Remarks/Arguments

Appl. No. 10/657,025  
Amdt. Dated September 21, 2004  
Reply to Office Action of July 8, 2004  
Annotated Sheet Showing Changes

**FIG. 6**

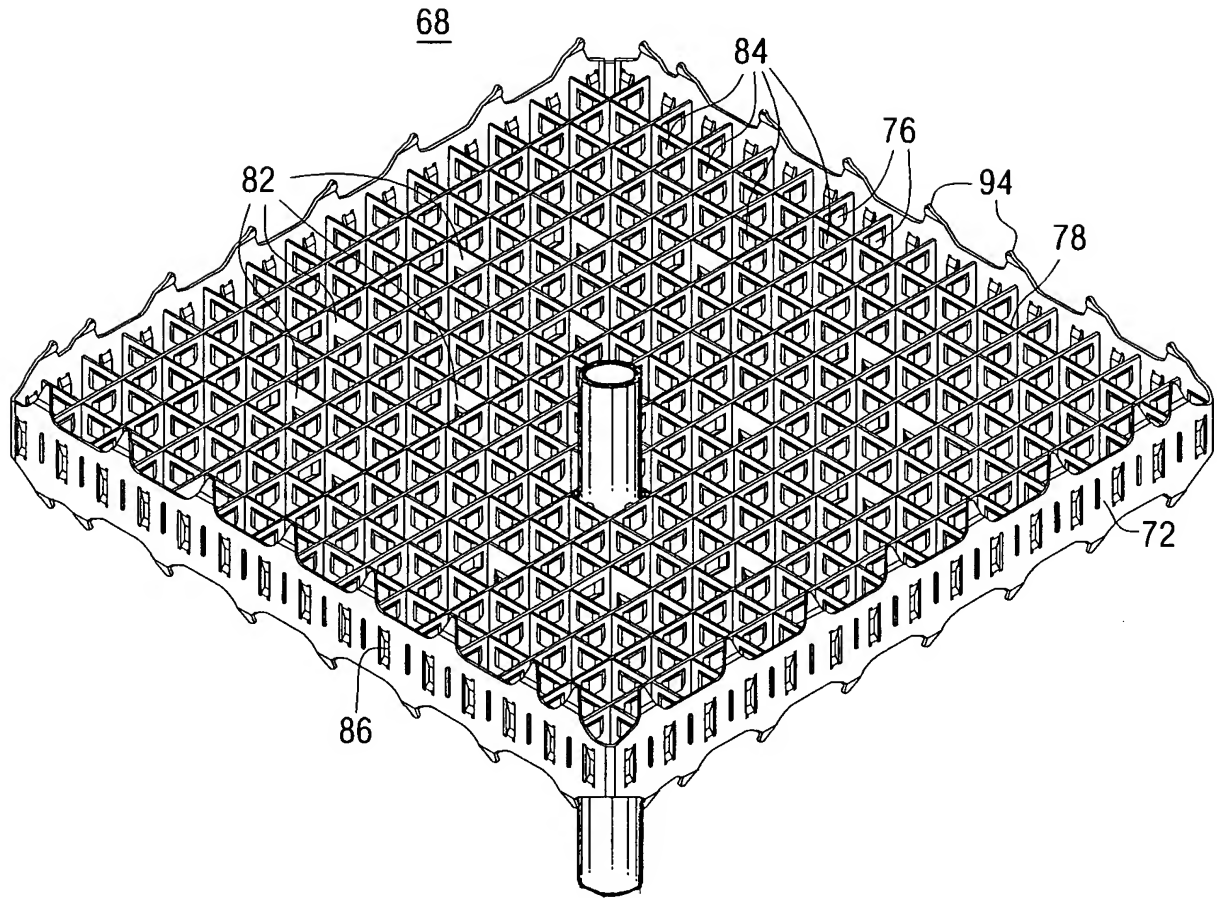
Claim 9 calls for the fuel assembly of Claim 8 wherein the dimples and/or springs on the walls of the respective auxiliary grid support cells are co-planar. Referring to Figure 6, it can clearly be seen that a common plane intersects both the vertical springs and the dimples, which is not the case in the main support grid design.

Claim 13 recites that the auxiliary grid is mechanically or metallurgically affixed to at least some of the guide tubes. The amended Figure 6 clearly shows the guide tube through an auxiliary grid attached at the cell corners by butt-welds. Accordingly, amended Claim 6 should cure the Examiner's objections to the drawings.

The attached sheet of drawings include changes to Figure 6. This sheet, which includes Figure 6, replaces the original sheet including Figure 6. In Figure 6, the previously omitted control rod guide tube showing corner welds to the grid cell has been added. Support for this addition may be found on page 11, starting at line 9 et sec.
